Memo

Subject: Private Plan Change 17 – Te Rapa North Industrial – Technical Specialist
Memorandum for Section 42A Reporting

Technical Area: Transportation

Figure 1 Revised Structure Plan.

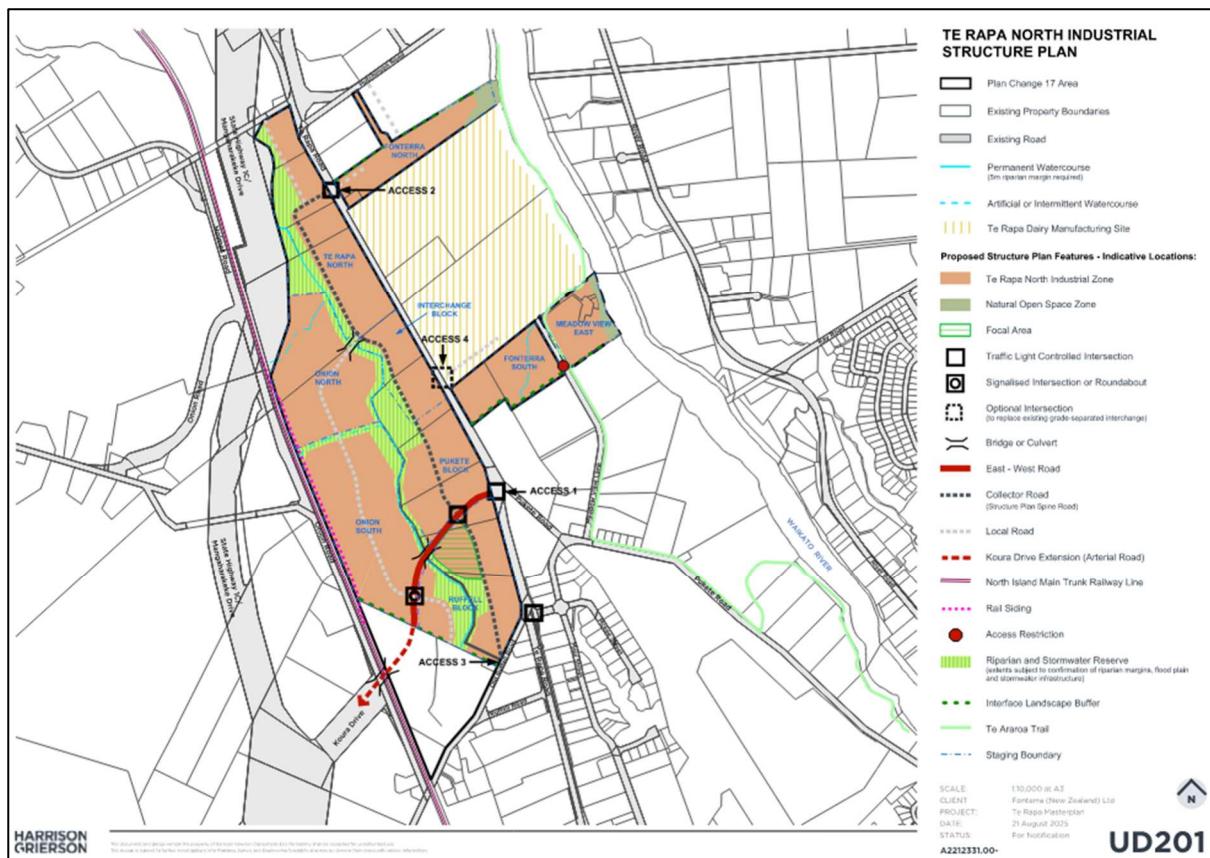
18. Compared to the lodged Structure Plan, the Revised Structure Plan includes land development names (Pukete Block, Ruffell Block. etc). However, the land development areas or stages are not indicated on the Revised Structure Plan and are not clearly identified in the Amended Provisions (Rule 3.9.3.2 Transport Upgrade Framework).

56. The Revised Structure Plan maps show a local road within the Dairy Manufacturing site, which is privately owned. The purpose of this road is unclear as it does not connect to Meadow View Lane and there is no provision requiring it to be formed.

65. The Revised Structure Plan illustrates the transport network including the east-west road and Koura Drive Extension (Arterial Road) outside the PPC17 area. Intersection upgrades are also indicated on the Revised Structure Plan including Access 1.

68. Access 4 (at the existing Dairy Factory Interchange) is indicated as an Optional Intersection (to replace existing grade-separated interchange) on the Revised Structure Plan. The Amended Provisions do not require or trigger the Access 4 intersection so it is unclear why it is shown.
